# Site Plan Review Committee (SPRC) Staff Report for Arva (2201 Arlington Blvd)

**Item 1. SPLN22-00006**

**Arva SPLN22-00006**  
(RPC# 18-059-020)

Figure 2-- Ground plan, courtesy applicant

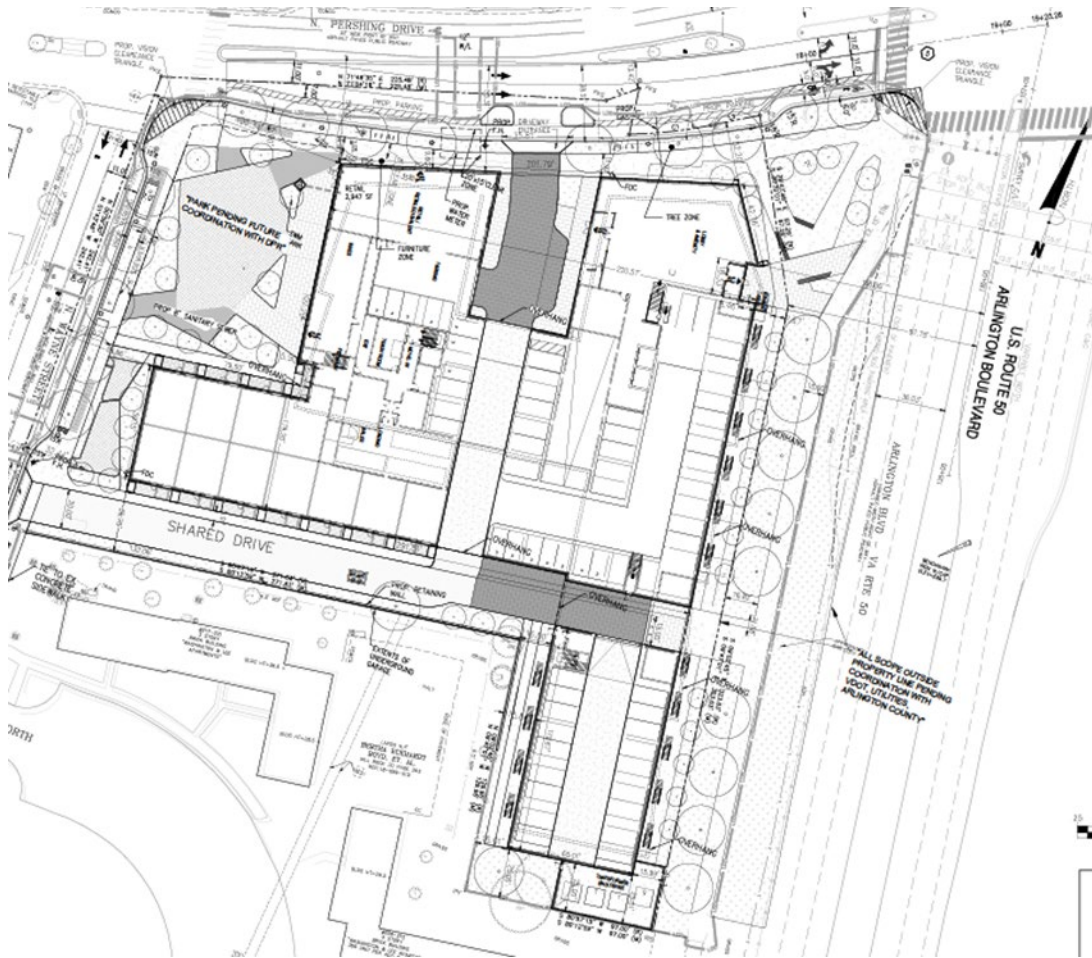
- Architecture/Urban Design: Areas of above grade parking create occasional blank walls and awkward urban design;
- Architecture/Urban Design: The architecture, especially above the second level, does not do enough to either reference the mid-Century architecture of the existing motel, nor the colors and architectural vocabulary of the earlier Washington-Lee Apartments.

- Public Space/Landscaping: The proposed public space includes areas for internal pedestrian site circulation and is also immediately adjacent to the retail space.

- Public Space/Landscaping: The proposed areas for the electrical transformers, while underground, create an area adjacent to both the Washington-Lee Apartments and the Arlington Boulevard façade that cannot be planted.

- Public Space/Landscaping: Landscaping does not entirely meet the recommendations of the GLUP Study document, especially on the south property line.
- Public Space/Landscaping: Can the proposed private dog run be moved elsewhere on the property? As proposed, it may need a taller fence to prevent dogs from escaping, which would have negative effect on the streetscape and the pedestrian experience walking on that side of North Wayne Street. It would also permit dwelling units adjacent to it to have windows or door openings onto that side of the façade. A dog run at an upper level of the building might also be easier for the building owner to treat waste and install AstroTurf for easier cleaning.
